## City of Fife Temporary Encampment

### Addendum #1

CITY OF FIFE  
 TEMPORARY VILLAGE

ELECTRICAL SERVICE PLAN  
 ELECTRICAL SITE PLAN

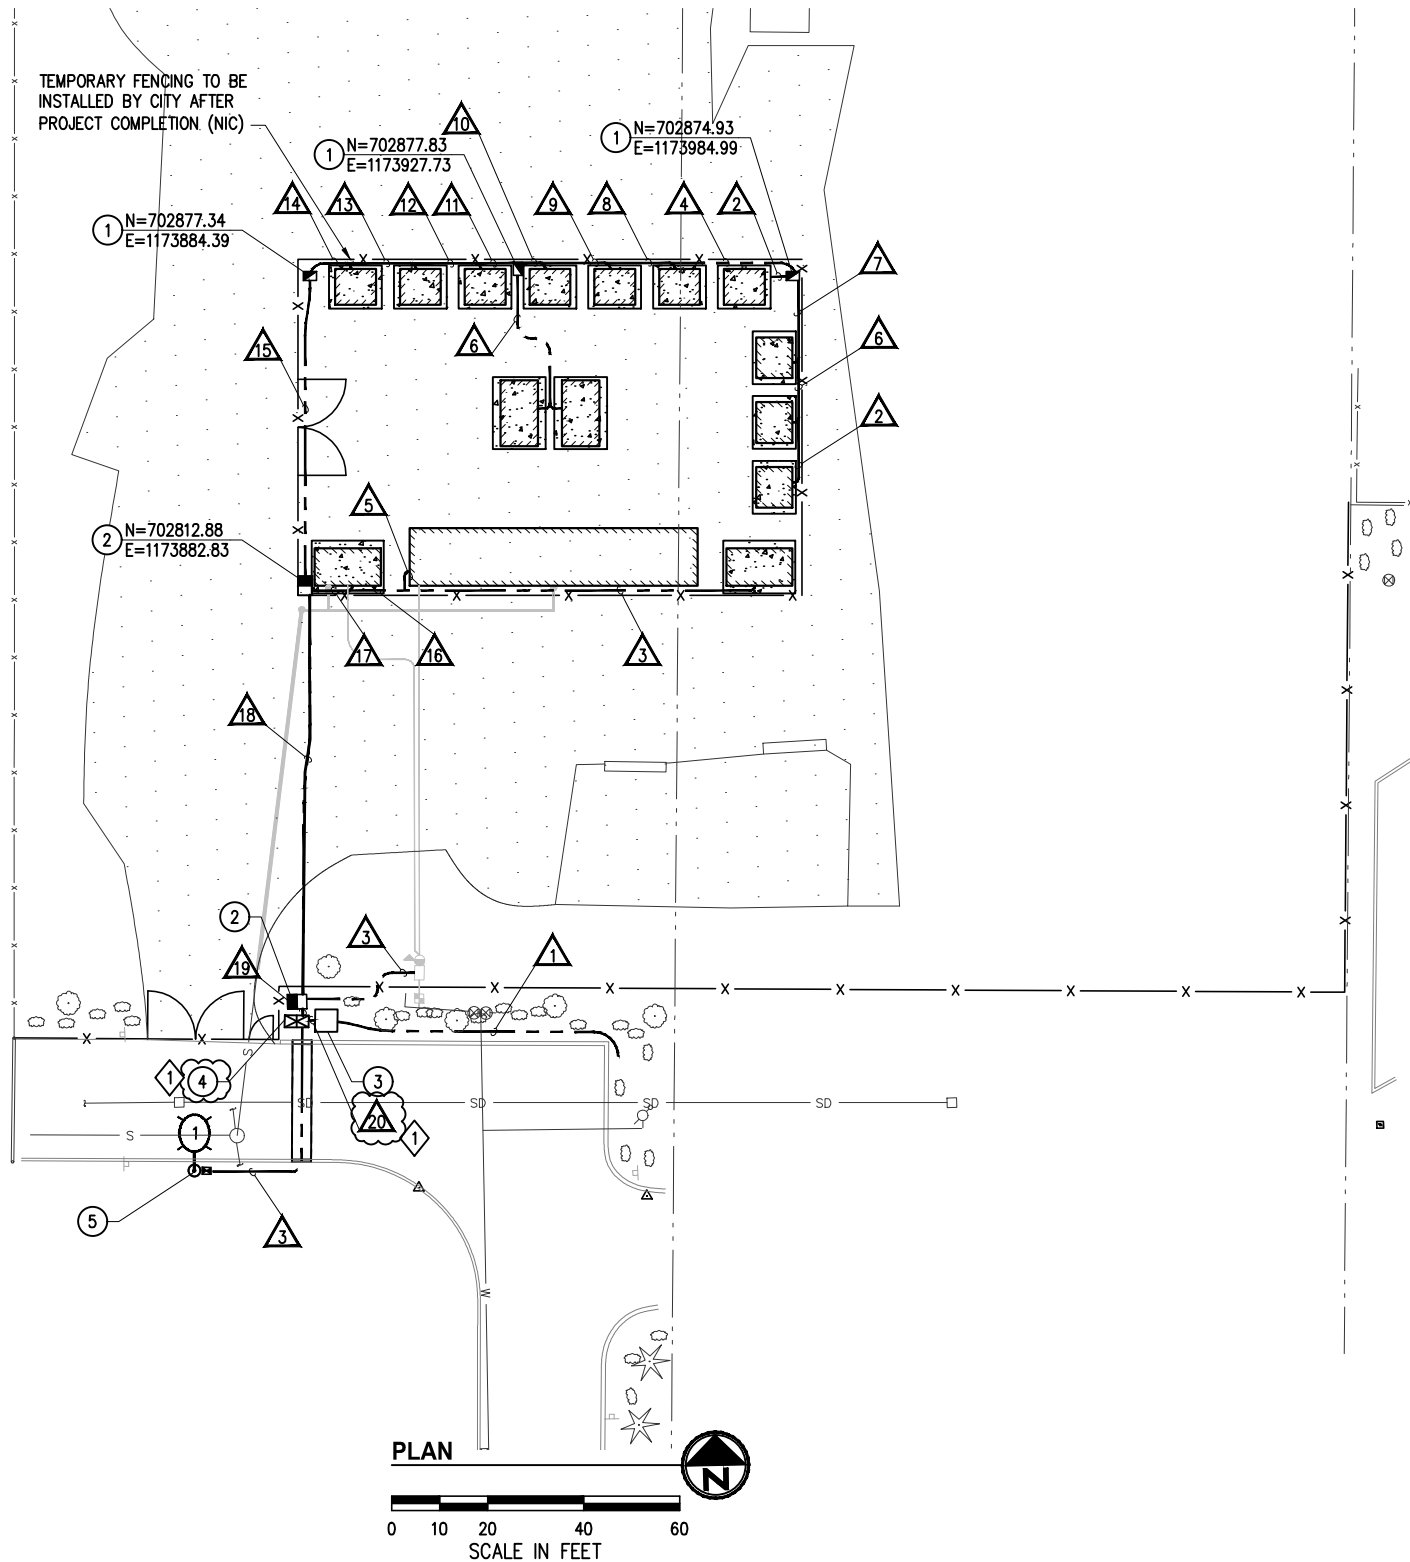
- a. Remove sheet 9 of 9 and replace with the attached.
  - i. Due to the difficulty for TPU to procure 400A meter bases, the City has opted to install two (2) 200A meter bases, rather than a single 400A.
- a. Clarification: Sheet 9 - The arm length is given as N/A due to the luminaire head being directly attached to the pole to match the other luminaires that exist onsite.

- CONTRACTOR TO FURNISH AND INSTALL TWO 120/240VOLT 200AMP ELECTRICAL SERVICE CABINETS AND METERS. CABINETS AND METERS SERVICE SHALL MEET REQUIREMENTS OF TACOMA PUBLIC UTILITY (TPU) AND THE NATIONAL ELECTRIC CODE (NEC). ONE ELECTRICAL SERVICE CABINET AND METER SHALL BE FOR THE MODULAR KITCHEN/LAUNDRY BUILDING WHILE THE OTHER SHALL BE FOR THE REST OF THE BUILDINGS AND THE STREET LIGHT. SEE SPECIAL PROVISIONS.
